SERVICE BULLETIN

from: TRIO-KENWOOD COMMUNICATIONS, INC.

SUBJECT: TS-180S LOW 40M ALC

DATE 9/14/79

▼ LPF UNIT (X51-1180-00)

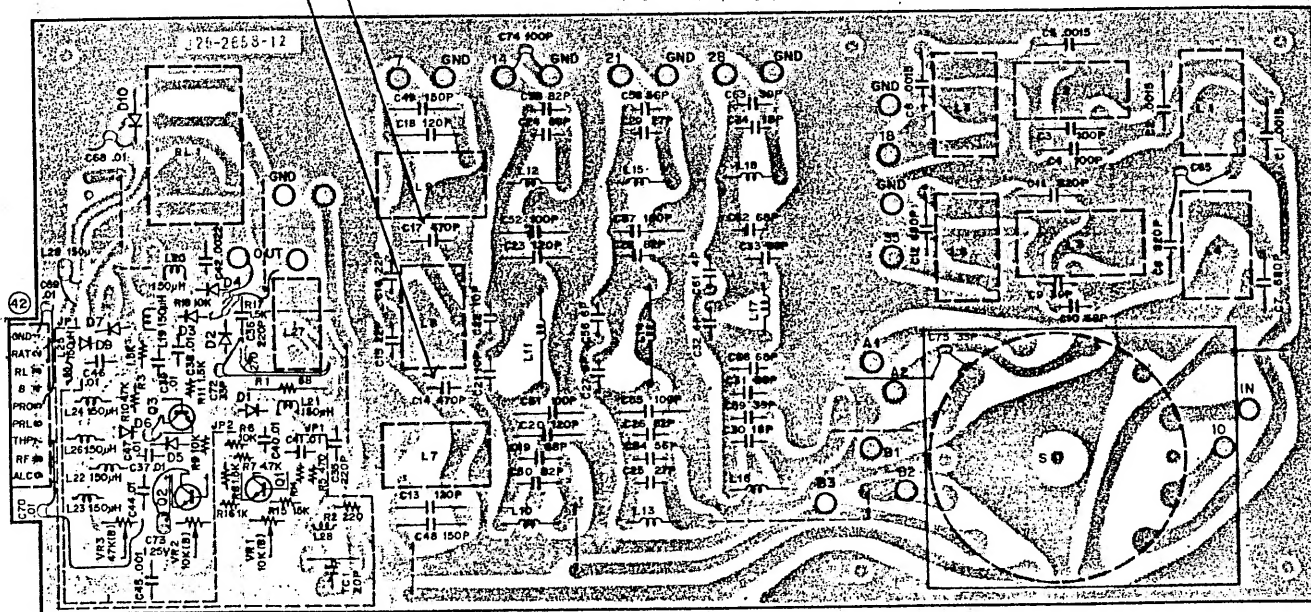
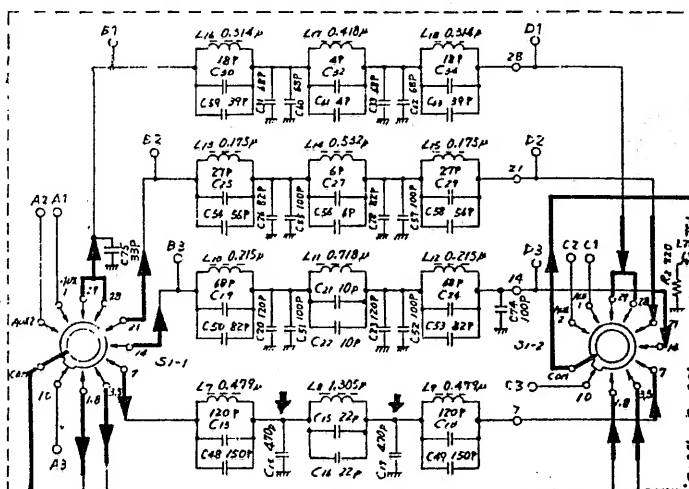
Some operators may experience intermittent reduction or loss of ALC, especially after several minutes transmit time.

On the LPF unit X51-1180-00, change C14, C17 from 470pF to 390pF. Check ALC level and adjust if necessary, per section 4-6 ALC meter adjustment, TS-180S Service Manual.

New Part: CM93D2H390J 390pf \pm 5% 500V mica or ceramic
